R E M A R K S

In addition, Figs. 1(a), 1(b), 6 and 7 have been amended, as indicated in red on the attached copies herewith.

FIG. 1(a)(1)

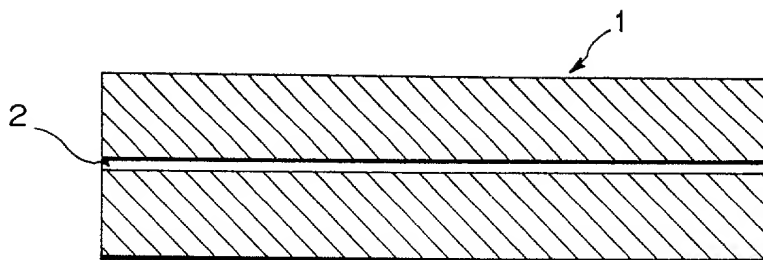
Fig. 1(a)(1) is a cross-sectional view of a part for an optical fiber connector according to a conventional method;

Fig. 1(a)(2) is a side elevational view of the optical fiber connector of Fig. 1(a)(1);

Specifically, Fig. 1(a) has been separated into Figs. 1(a)(1) and 1(a)(2), Fig. 1(b) has been separated into Figs. 1(b)(1) and 1(b)(2), numeral 9 has been added to refer to the positive electrode in Fig. 6, and Fig. 7 has been separated into Figs. 7(a) and 7(b).

FIG. 1(b)(1)

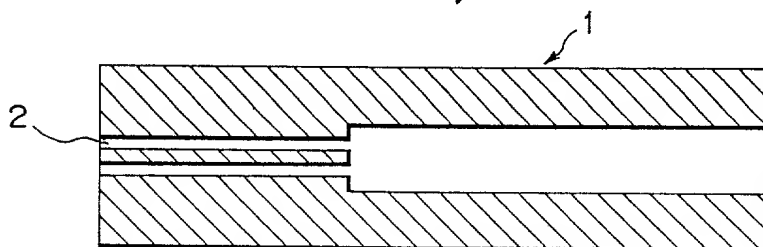
Fig. 1(b)(1) is a cross-sectional view of a part for an optical fiber connector according to another conventional method;

Fig. 1(b)(2) is a side elevational view of the optical fiber connector of Fig. 1(b)(1);

FIG. 6

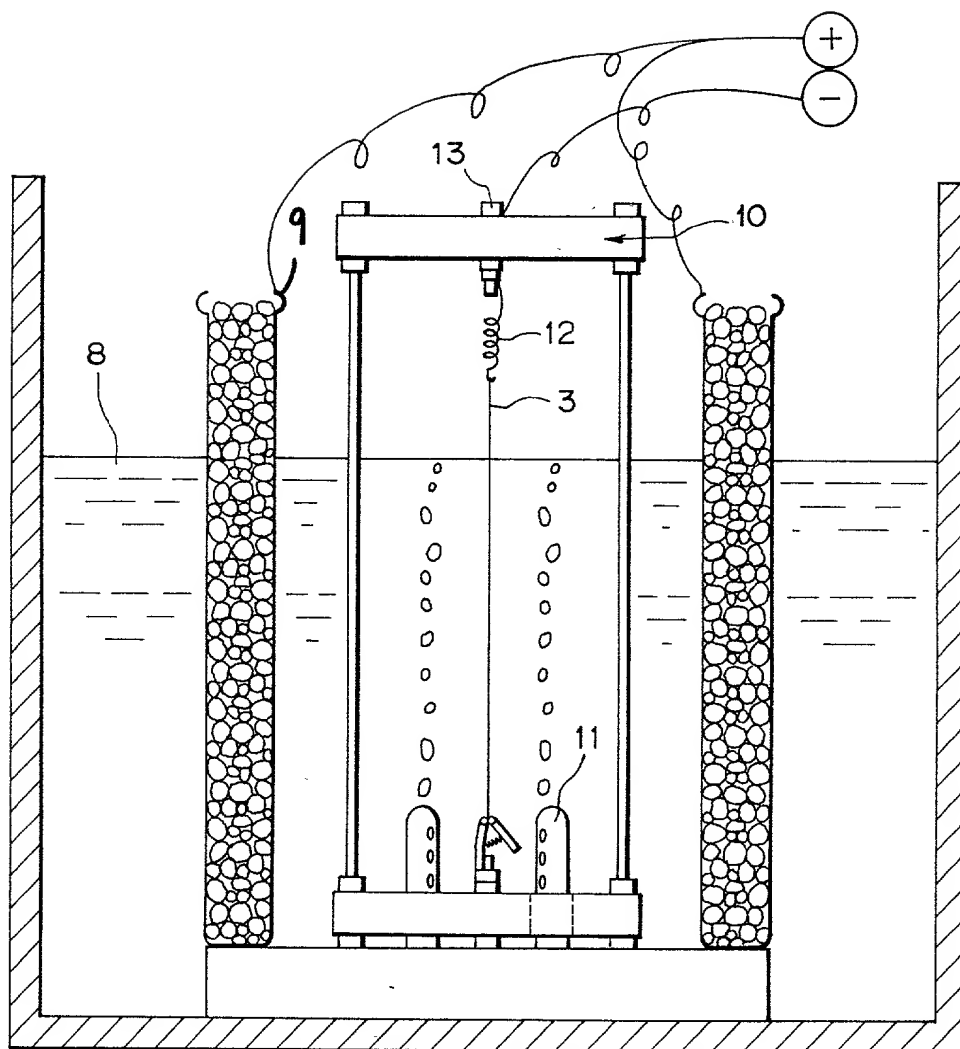
An electroforming device is schematically shown in Fig. 6. In Fig. 6, the electroforming device comprises an electroforming liquid 8, a positive electrode 9, a supporting jig 10, an air stirring nozzle 11, a spring 12, a negative electrode 13, and a wire 3.

FIG. 7(a)

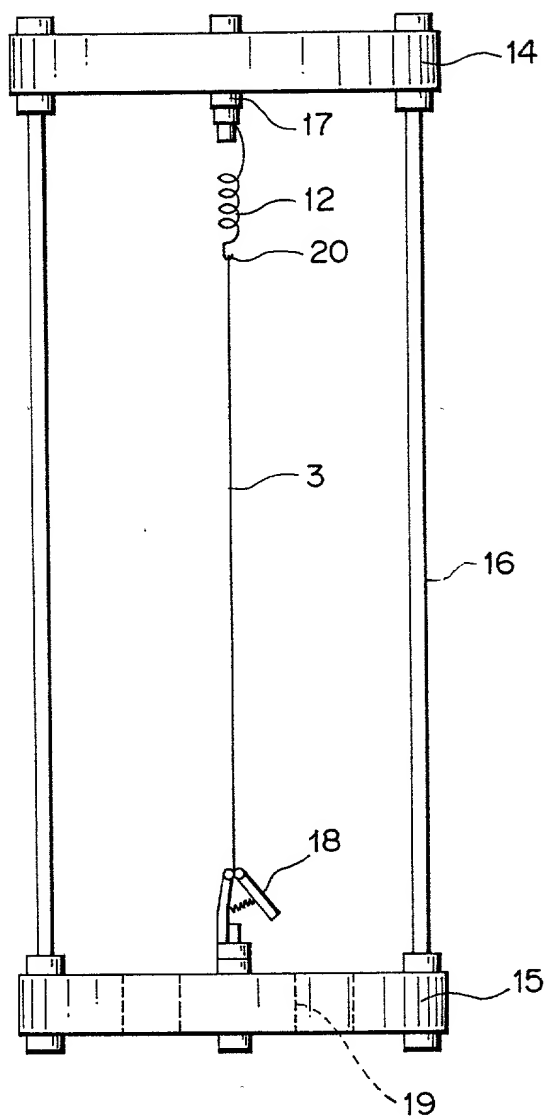
Fig. 7(a) is a side view showing one example of a supporting jig according to the present invention;

Fig. 7(b) is a plan view of the supporting jig of Fig. 7(a); and
